LOCATION OF
BARGE CANAL AND HARBOR
AT ROCHESTER, N. Y.

REPORT BY LYMAN E. COOLEY.

Barge Canal - Lockport to Rochester.

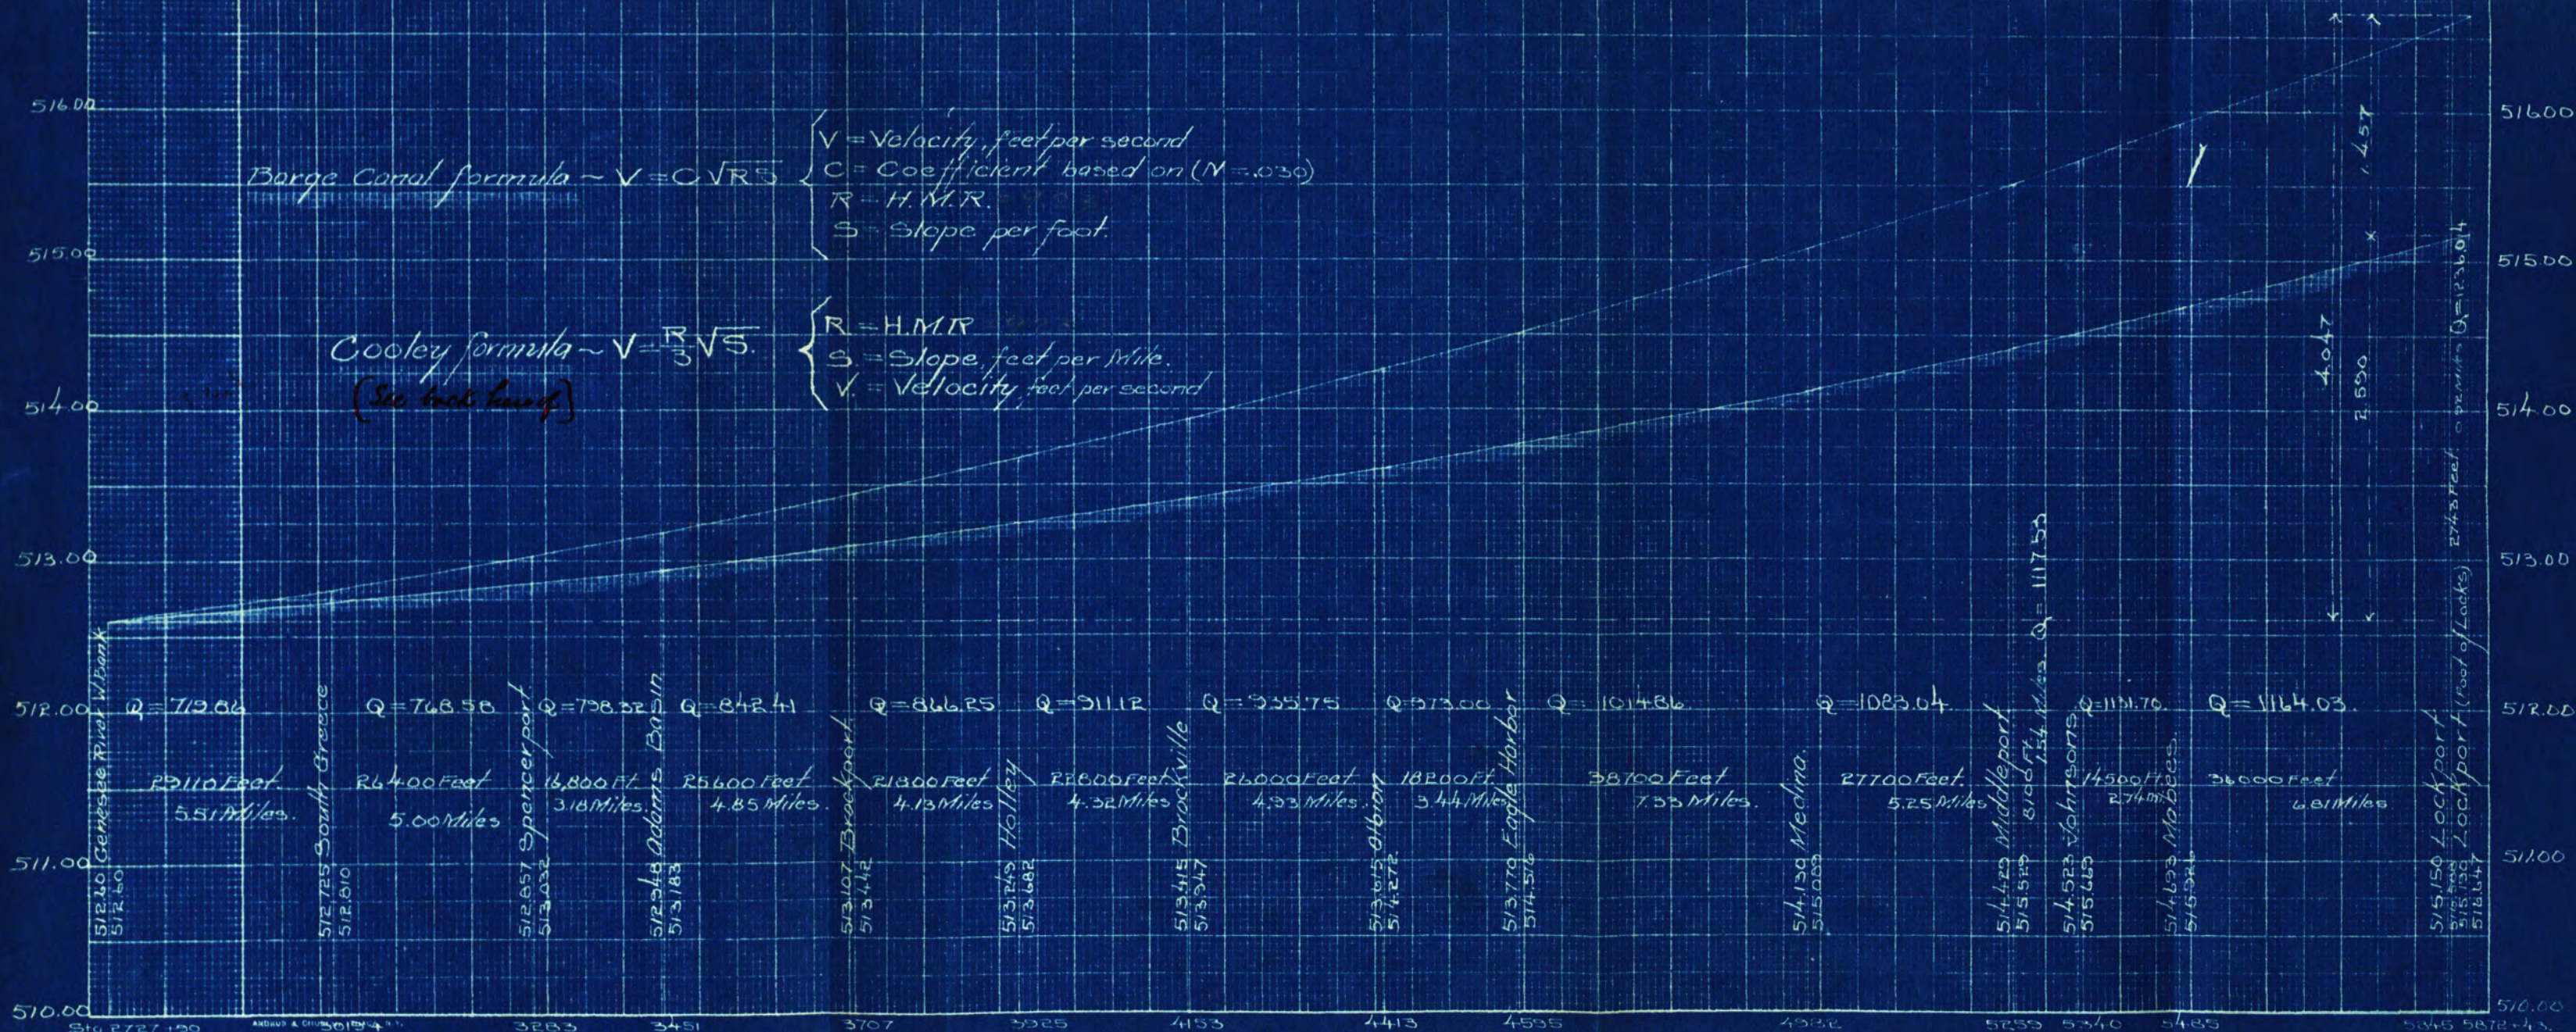
Coolidge's formula: $v = \frac{r}{3} \sqrt{S_0}$ || S_0 = fall in feet per mile = 5280. S_0 . Said to be based on observations on Chicago Dred Canal.
whence: $v = \frac{r}{3} \sqrt{5280 \cdot S_0} = \frac{\sqrt{5280 \cdot r}}{3} \cdot \sqrt{S_0} = \frac{72.6636}{3} \cdot \sqrt{r} \cdot \sqrt{S_0} = 24.2212 \sqrt{r} \cdot \sqrt{S_0} = \alpha \sqrt{r S_0}$ || $\log \alpha = 1.8667978$

This is a very small value for so large a channel.

we have: $C \sqrt{r S_0'} = \alpha \sqrt{r S_0''}$, or $\frac{C}{\alpha} = \sqrt{\frac{S_0''}{S_0'}}$, or $\frac{S_0''}{S_0'} = \left(\frac{C}{\alpha}\right)^2 = \left(\frac{92.1073}{73.5864}\right)^2 = (1.2517)^2 = 1.5667$

hence on the average we have S_0'' (Coolidge) is $1.5667 \cdot S_0'$ (Kutter).
